Item Name: Quick Release Heli-Utility-Basket™ Long, HD Lid, Spacepod™/Squirrel Cheek Comp. Stop *NS2*

DART SERVICE INSTRUCTION

TO AMEND INSTALLATION INSTRUCTIONS D350-607-3 Rev.D,
INSTALLATION INSTRUCTIONS D350-607-4 Rev. C AND
INSTRUCTIONS FOR CONTINUED AIRWORTHINESS ICA-D350-607 REV. 6
REF TCCA STC: SH94-14
REF FAA STC: SR00213NY
REF EASA STC: EASA.10016996
REF BRAZILIAN STC: 2007S03-03/-04/-05/-06

A	NEW ISSUE	AJS	14.05.16
REV.	DESCRIPTION	BY	DATE
DESIGN	AJS	DART AEROSPACE LTD HAWKESBURY, ONTARIO, CANADA	
DRAWN	AJS		
CHECKED	N/A	DRAWING NO. REV. A	
MFG. APPR.	N/A	DSI 9699 SHEET 1 OF 2	
APPROVED		TITLE SCALE	
DE APPR.		LUG REPLACEMENT NTS	
DATE	14.05.16	COPYRIGHT © 2014 BY DART AEROSPACE LTD THIS DOCUMENT IS PRIVATE AND CONFIDENTIAL AND IS SUPPLIED ON THE EXPRESS CONDITION THAT IT IS NOT TO BE USED FOR ANY PURPOSE OR COPIED OR COMMUNICATED TO ANY OTHER PERSON WITHOUT WRITTEN PERMISSION FROM DART AEROSPACE LTD.

FIGURE 1: INSTALLATION OF D4775-041 FWD STRUT

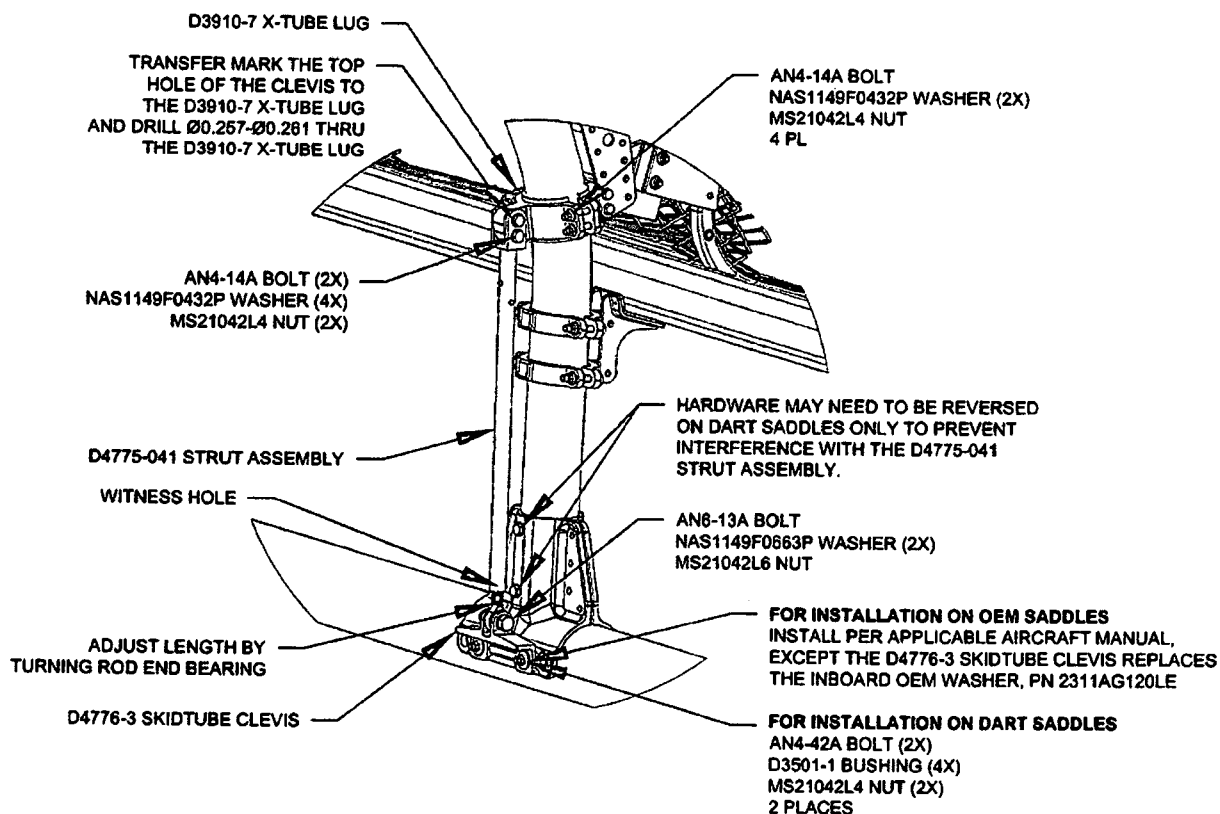
- 3.1 Substitute the Forward Lower D3910-5 X-Tube Lug with the D3910-7 X-Tube Lug as shown in Figure 1.
- 3.2 Install the forward D4775-041 Strut Assembly. Transfer mark from the upper hole on the clevis of the D4775-041 Strut Assembly to the D3910-7 X-tube Lug and drill thru the lug $\varnothing 0.257 - \varnothing 0.261$ as shown in Figure 1. Touch up chemical conversion coating per MIL-DTL-5541. Check the witness holes located at the bottom end of the D4775-041 Strut Assemblies to ensure that the thread from the rod end extends past the witness hole.
Torque MS21042L4/-4 nuts to 50-70 in-lbs (5.7-7.9 N-m). Torque MS21042L6/-6 nuts to 160-190 in-lbs (18.1-21.5 N-m).
- 3.3 Complete the installation in accordance with Installation Instructions D350-607-3 Rev. D or D350-607-4 Rev. C.
